TRANS/WP.29/GRSG/1999/15
27 July 1999

PROPOSAL FOR DRAFT AMENDMENTS TO REGULATION No. 52
(Small capacity public service vehicles)

Transmitted by the Secretariat

"5.7.4. Access to escape hatches

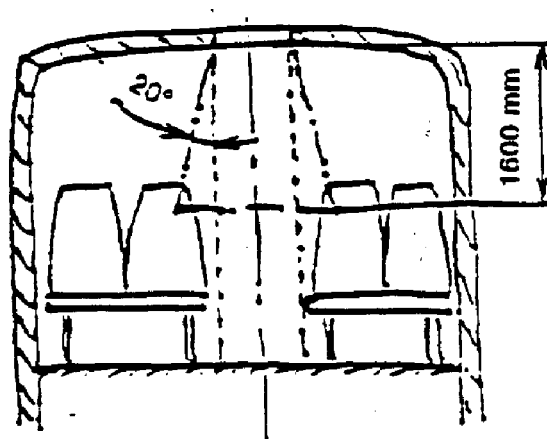
Paragraph 5.7.4., amend to read:

5.7.4.1. For Class B vehicles, at least one escape hatch shall be located such that a four-sided truncated pyramid having a side angle of 20° and a height of 1,600 mm touches part of a seat or equivalent support. The axis of the pyramid shall be vertical and its smaller section shall contact the aperture area of the escape hatch. Supports may be foldable or movable provided they can be locked in their position of use. This position shall be taken for verification.

5.7.4.2. When the structural thickness of the roof is more than 150 mm, the smaller section of the pyramid shall contact the aperture area of the escape hatch at the level of the outside surface of the roof."

Figure 8
PERMITTED INTRUSION OF A CONDUCT
(See paragraph 5.7.8.1.3.3.)

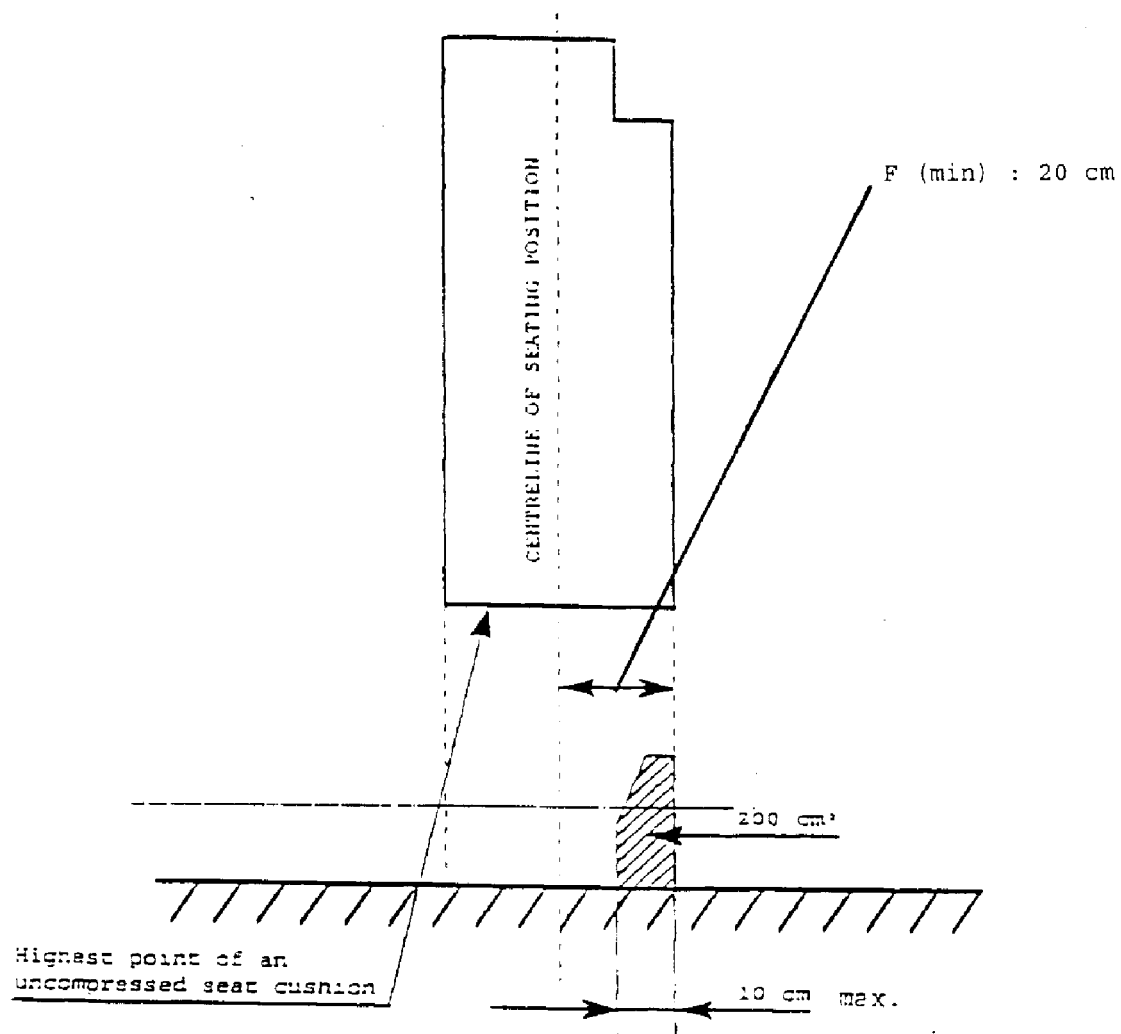
Paragraph 5.7.8.1.3.3., amend to read:

"5.7.8.1.3.3. Intrusion of a conduit (e.g. for a hot air) situated in the lower part"

Annex 3, figure 8, replace by the following figure:
